Access Compliance Report

(Curb Ramps)

Intersection ID: 28012	Main Street: EDINDALE_DR	Cross Street: PROVIDENCE_RD_WEST	Location: NW
ADA ID: 610357702818	Ramp Type: Directional1	Initial Pass/Fail: Fail	Overall Compliance: No
Severity Score: 1.25			
Codes/Mitigation Info/Possible Solution		Field Measurements/Component Compliance

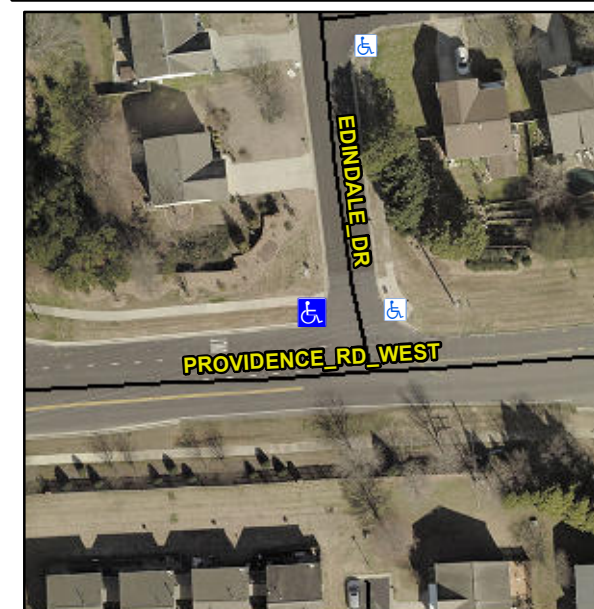
Compliance	Description	Data	Compliance	Description	Data
N/A	Ramp Length (in)	78.0	N/A	Grade Break?	N/A
Yes	Ramp Width (in)	59.0	N/A	Grade Break Slope (%)	0.0
Yes	Ramp Slope (%)	6.3	N/A	Grade Break XSlope (%)	0.0
No	Ramp XSlope (%)	3.5			
N/A	Flare Type LT	N/A	N/A	Flare Type RT	N/A
N/A	Flare Slope LT (%)	N/A	N/A	Flare Slope RT (%)	0.0
N/A	Flare Traversable LT?	N/A	N/A	Flare Traversable RT?	N/A
N/A	Landing Length (in)	0.0	N/A	DWS Provided?	N/A
N/A	Landing Width (in)	0.0	N/A	DWS Contrast?	N/A
N/A	Landing Slope (%)	0.0	N/A	DWS Length (in)	N/A
N/A	Landing X Slope (%)	0.0	N/A	DWS Full Width?	N/A
N/A	Landing Curb? (Y/N)	N/A	N/A	DWS Offset LT (in)	N/A
N/A	Shared Landing?	N/A	N/A	DWS Offset RT (in)	N/A
N/A	Gutter Ponding?	0.0	N/A	Gutter Slope (%)	N/A
N/A	Gutter Lip Ht (in)	0.0	N/A	Gutter X Slope (%)	N/A
N/A	Painted X Walk1?	No		Road Slope (%)	3.2
	X Walk 1 Direction	To E		Road X Slope (%)	7.2
	X Walk 1 Width (in)	N/A		Clear Space?	N/A

Remove & Replace Entire Ramp.

R304.5.3
